**BELL SYSTEM PRACTICES**  
**Station Installation and Maintenance**

**ADDENDUM C32.505**  
**Issue 1, 5-31-46**  
**AT&T Co Provisional**

**TELEPHONE SETS**  
**NORTH ELECTRIC**

Fig. 1

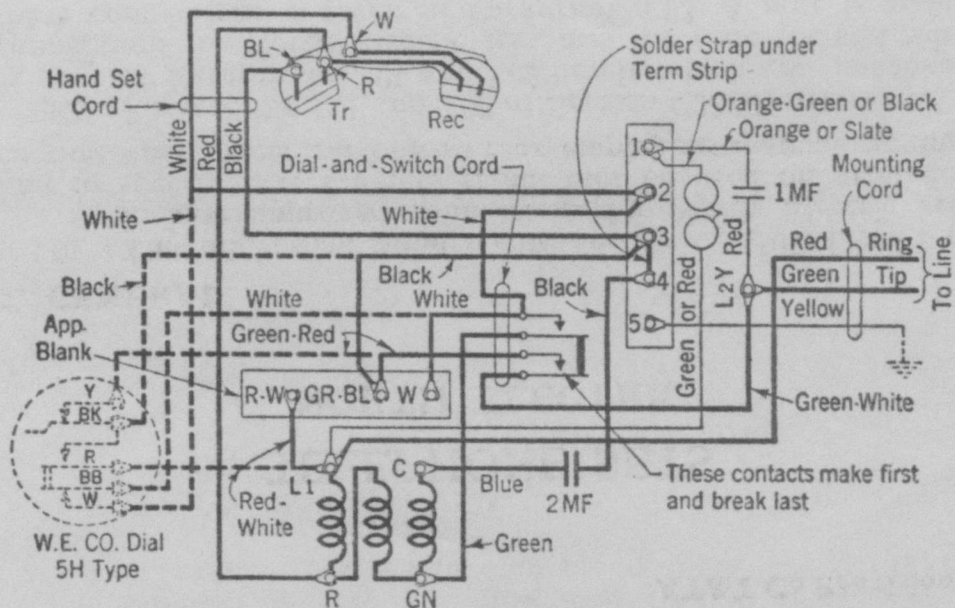
3.01 The connections for North Electric telephone sets are shown in Fig. 1 herein which replaces Fig. 1 of the section. The new connections should be provided for all new installations, reinstallations and additions of dials to the sets. Likewise whenever customer complaints of dial or switch clicks

at existing installations are received or repairs are made which require reconnections at set terminals, such as hand set, dial or cord replacements, the set connections should if necessary be changed to conform with those shown herein. These changes include the following:

- (1) Remove black condenser lead from L2Y of induction coil and connect it to Terminal 4 on terminal block.
- (2) Transfer green lead from L2Y to GN on induction coil.
- (3) Remove green-white lead from Terminal 3 of terminal block and connect it to L2Y of induction coil.
- (4) Remove black lead from L1 of induction coil and connect it to Terminal 3 on terminal block.
- (5) Transfer black conductor of hand set cord from Terminal 2 to Terminal 3 on terminal block.
- (6) Where a dial is added, transfer connections on apparatus blank to dial.

New and repaired sets with the improved connections may be identified by the code 5H6SLD stamped on the underside of the base.

Note: If the free length of the white conductor of the hand set cord is too short to permit terminating this conductor at the W terminal of the dial, replace the cord with H3C-9 or equivalent cord.

3.02 The diagram in Fig. 1 shows the line and ringer connections are for bridged ringing lines. Line and ringer connections for bridged and grounded ringing lines of the classes of service for which the set is used are given in Table 1.
